**BROWN REYNOLDS WATFORD  
ARCHITECTS**

## ADDENDUM NO. 04

**PROJECT:** LOS FRESNOS CITY HALL  
**LOCATION:** LOS FRESNOS, TEXAS  
**PROJECT NO:** 217072.00  
**DATE:** July 17, 2018

The Construction Documents on the above referenced project, dated 6/11/18, shall be revised as follows:

**1 SITE PLAN**  
1" = 20'-0"

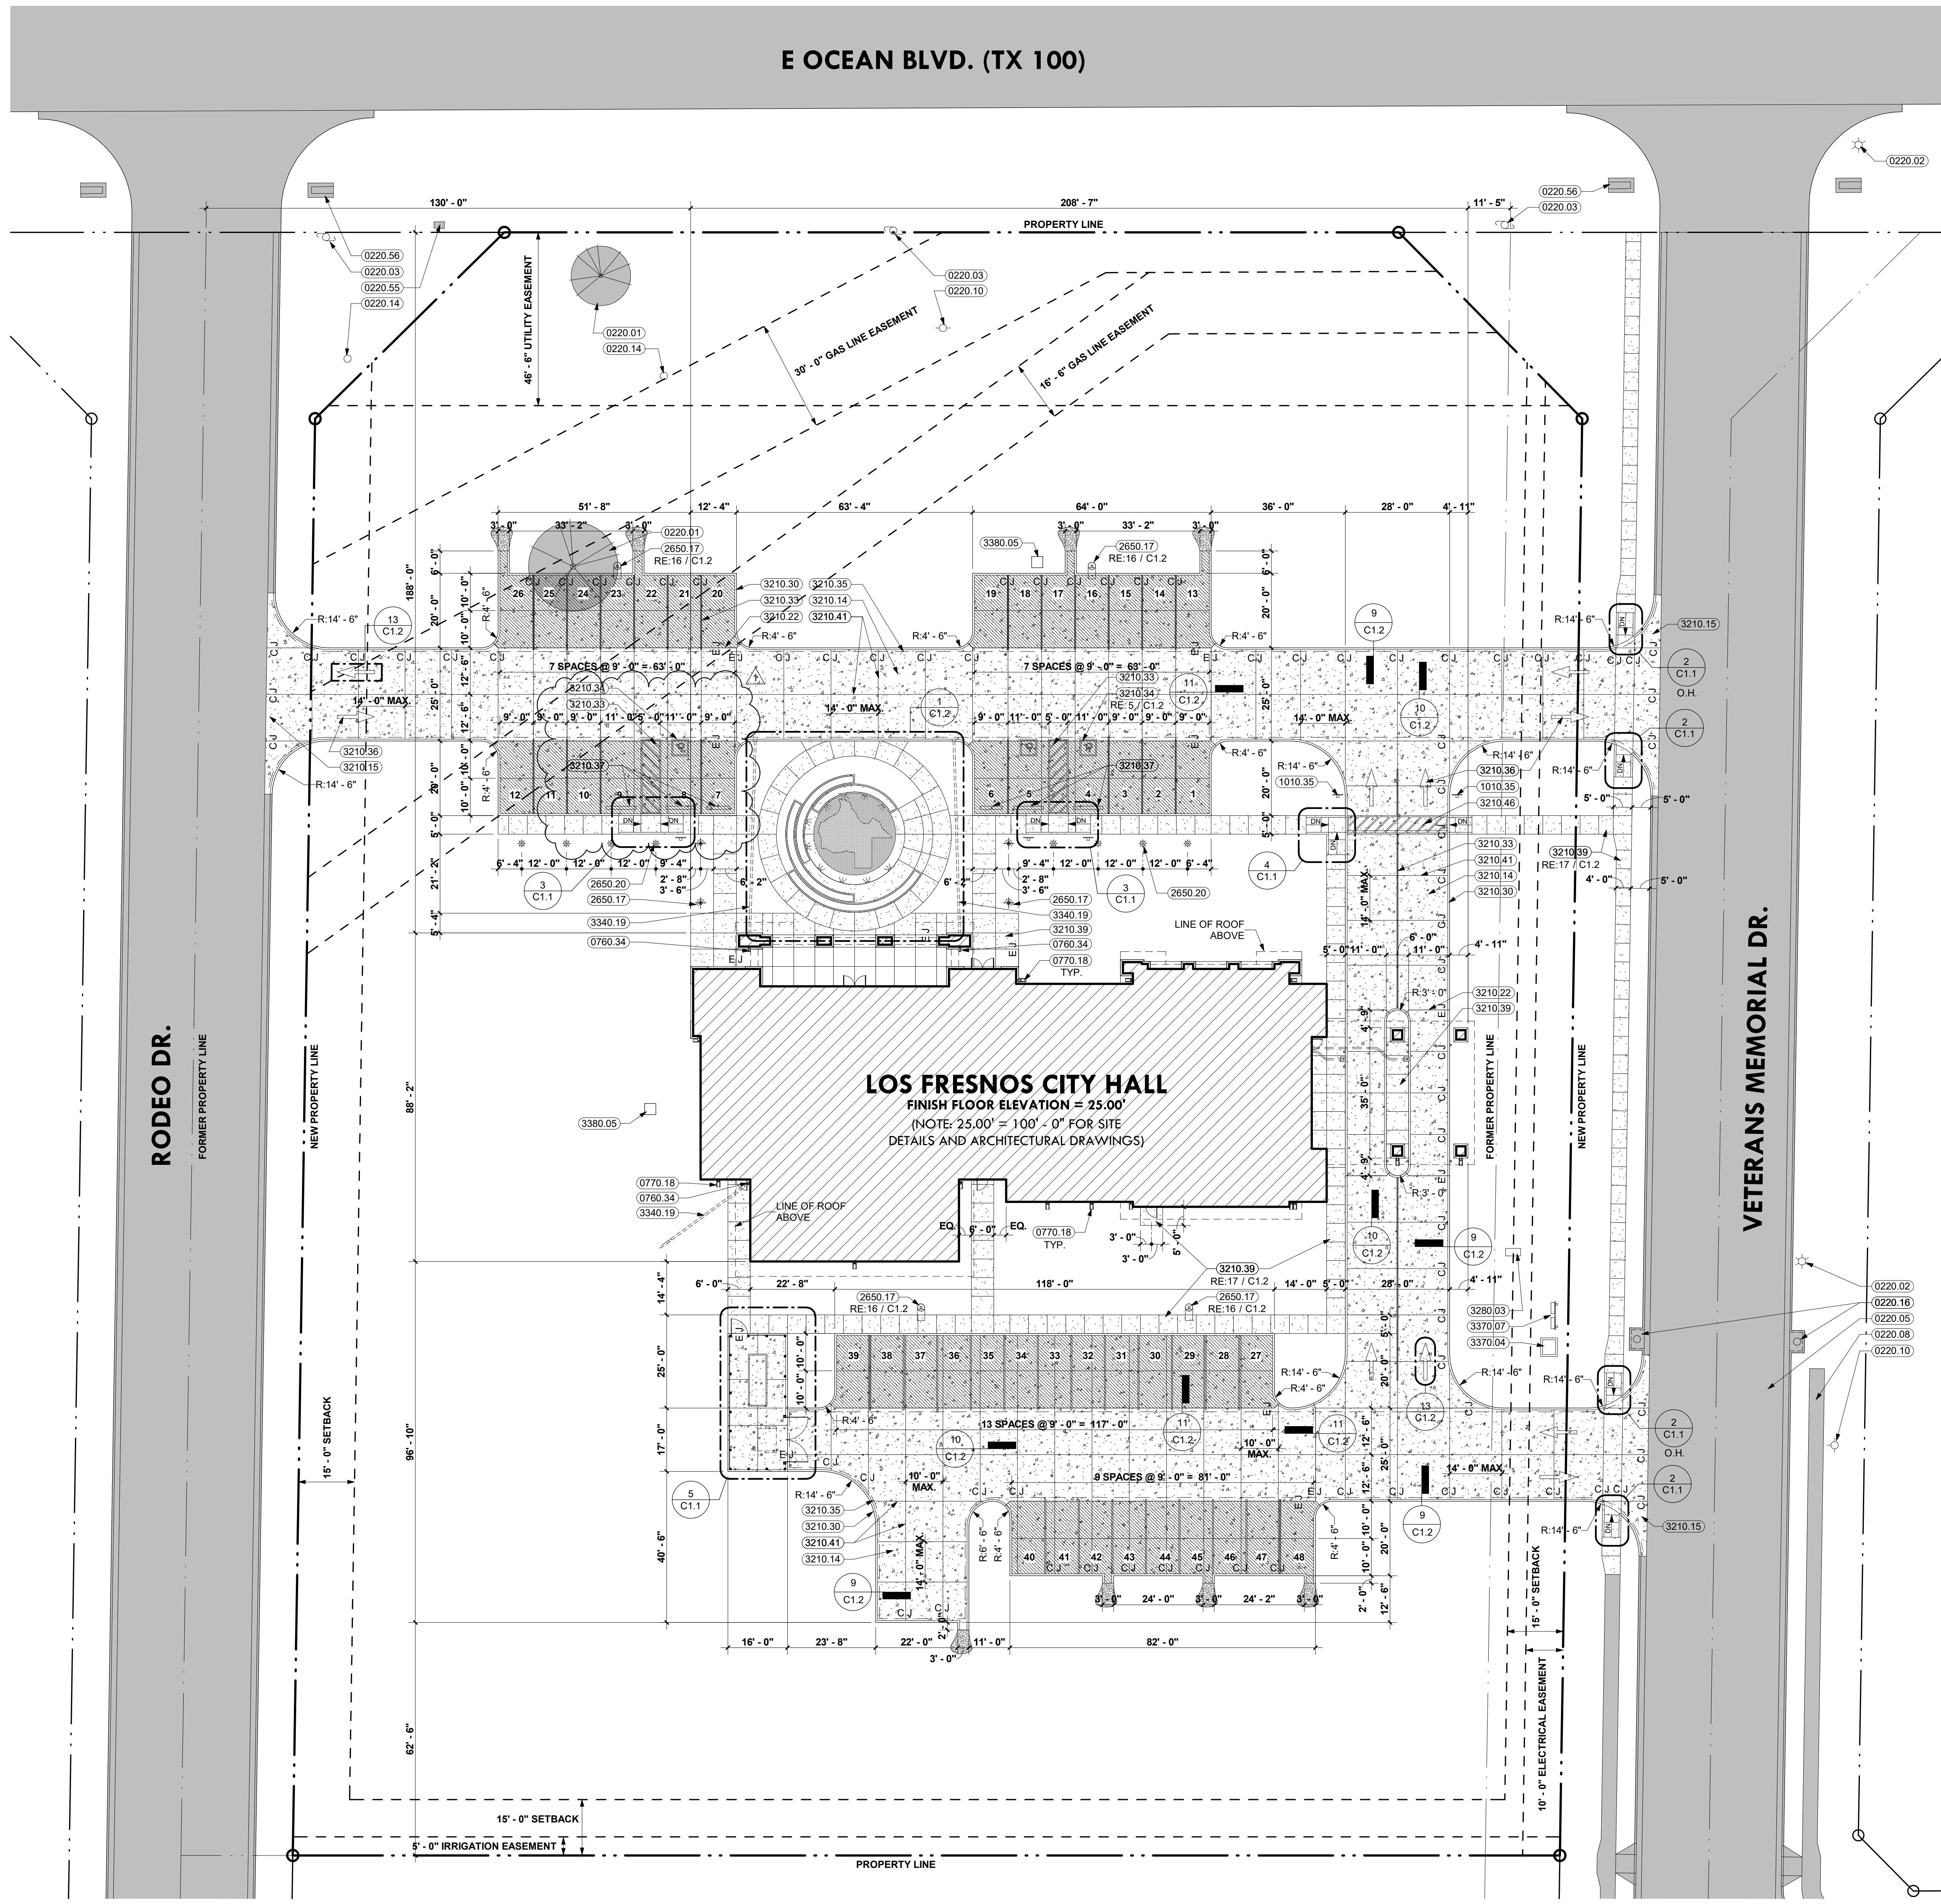
- Item No. 1** (RE: Sheet C1.1, Detail 1) - One additional van accessible parking space is added on the west side of the visitor parking area. The access aisle and ramp arrangement is mirrored from the east side. This change is reflected in attached revised sheets **C1.1, C1.3, C1.4, L1.1, and L1.2.**

**1 GRADING PLAN**  
 1" = 20'-0"

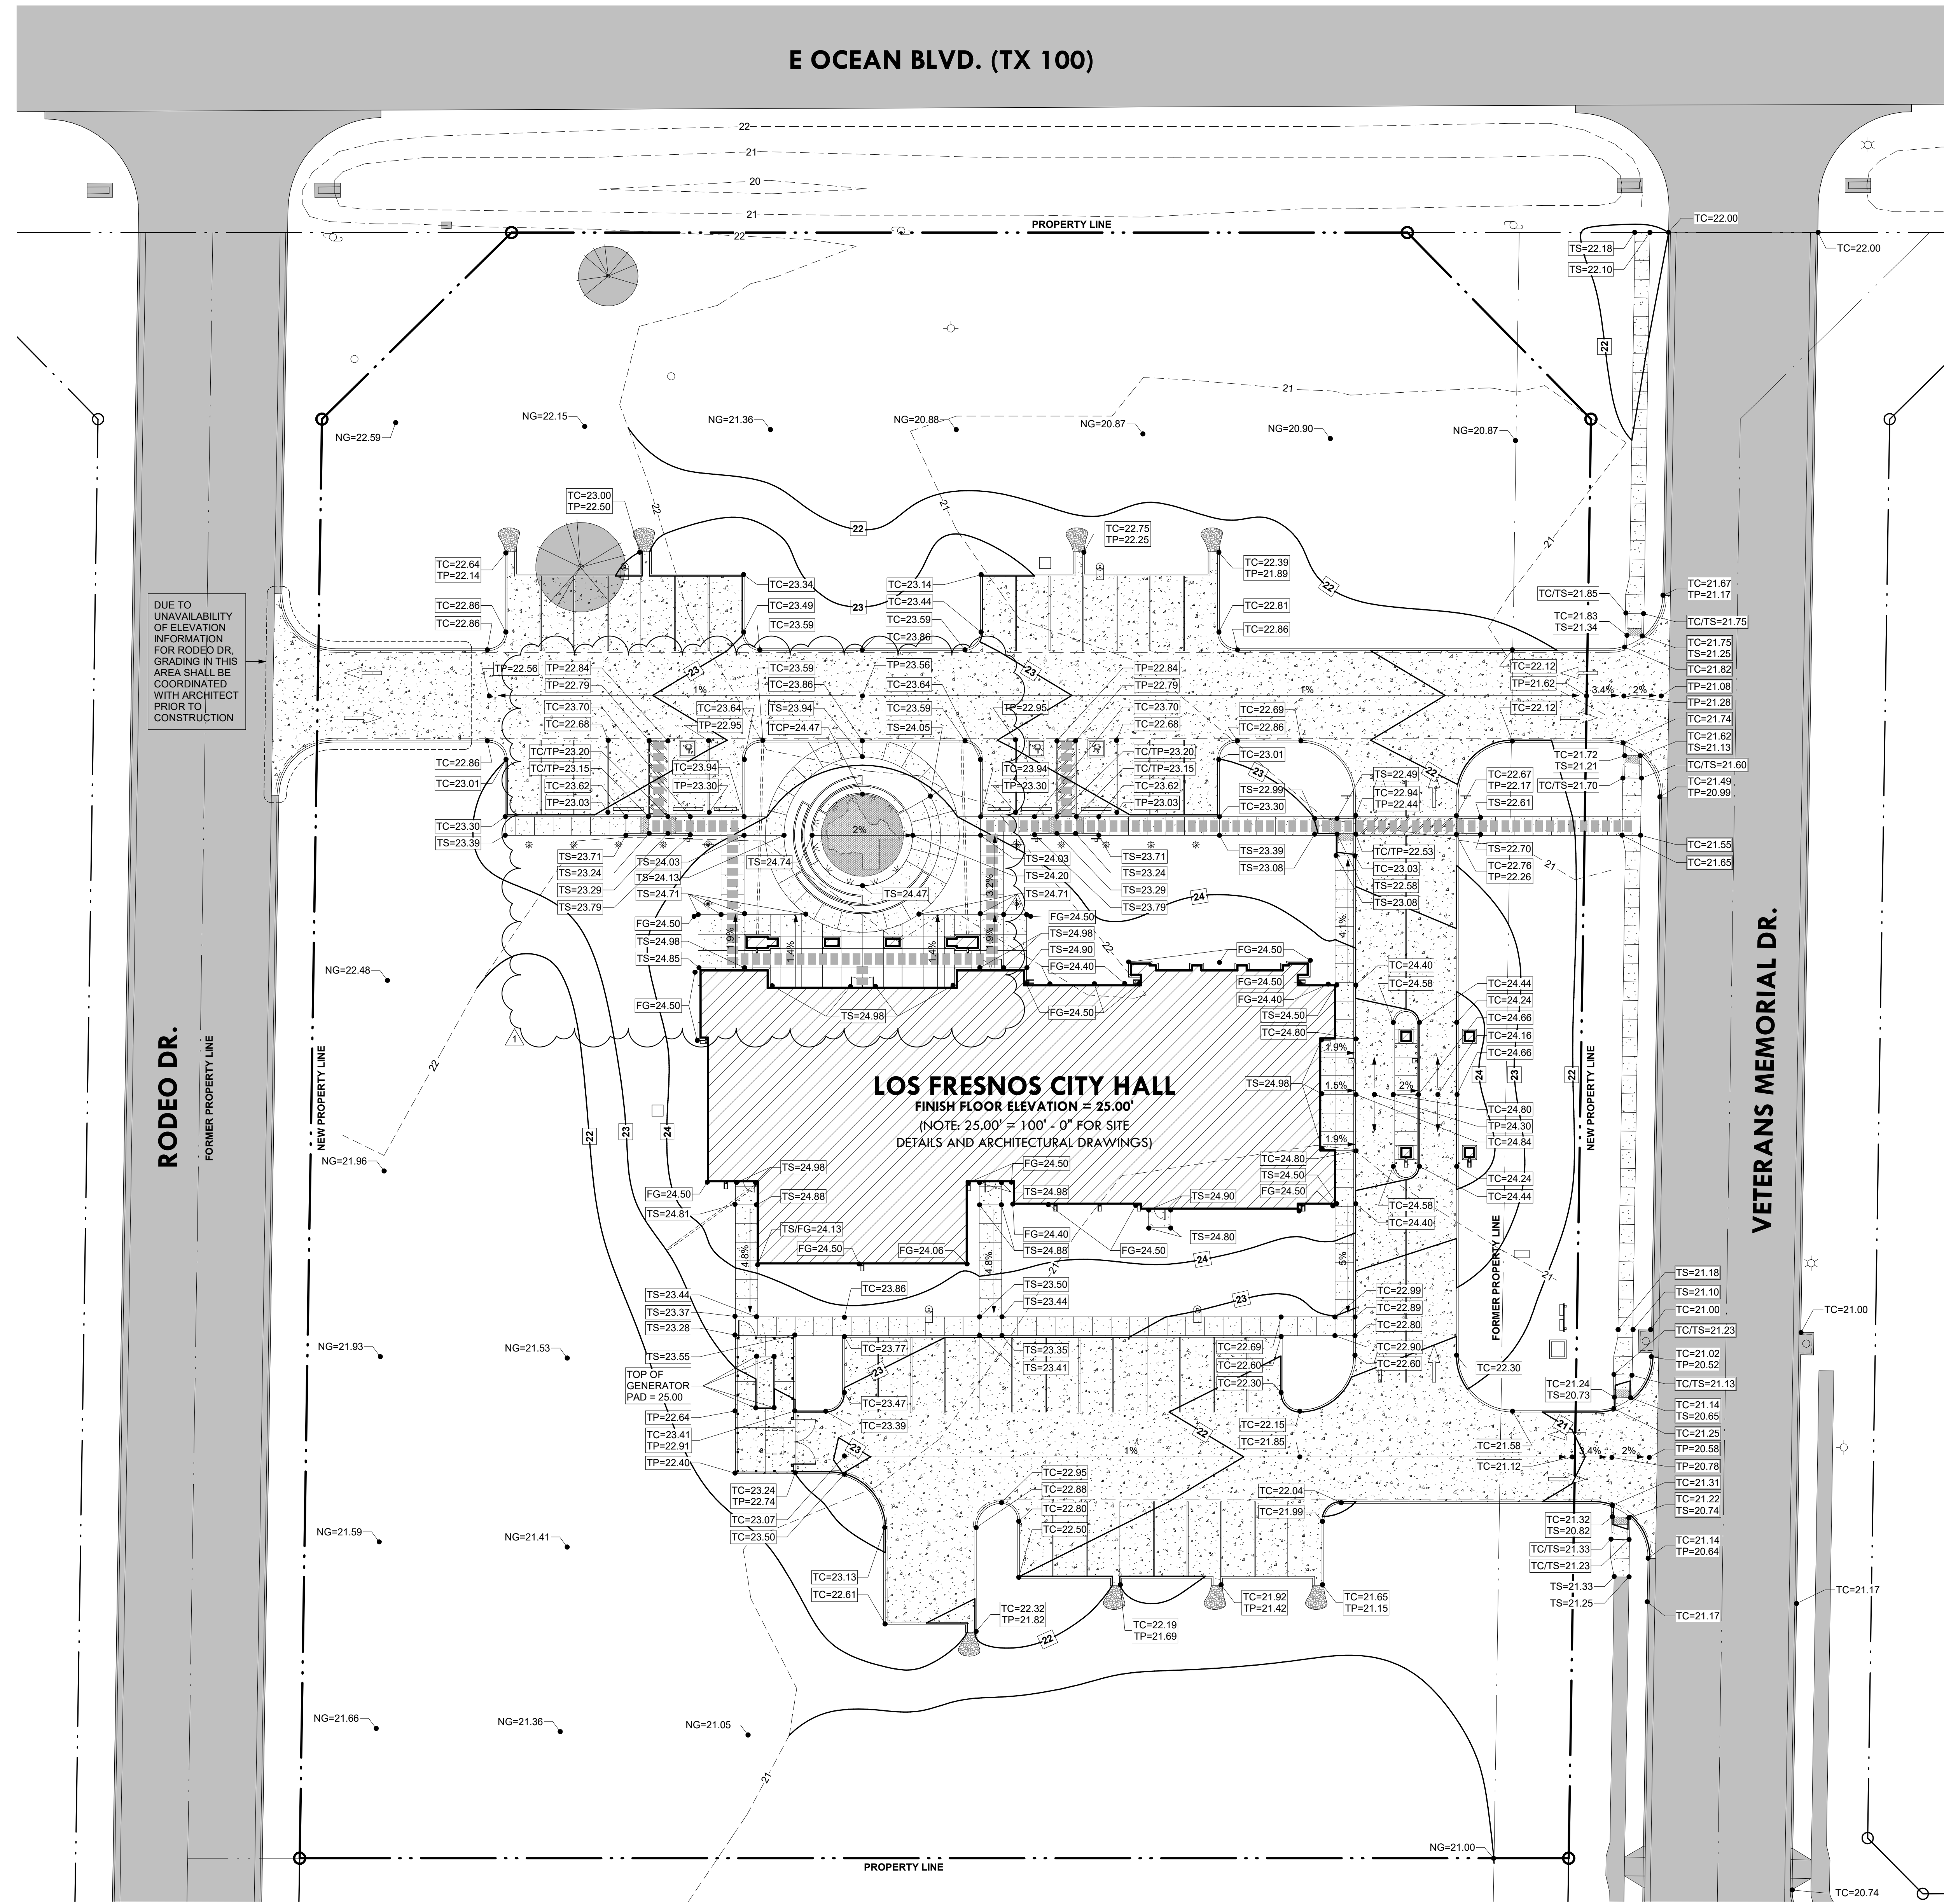
**Item No. 9** (RE: Sheet C1.3, Detail 1; Section 01 23 00 Alternates) - If Alternate #4 is accepted, some areas will remain as concrete paving, as indicated by the hatch patterns on C1.3. These areas include the driveway aprons, dumpster turn around, and the portion of the drive thru lane(s) underneath the canopy.
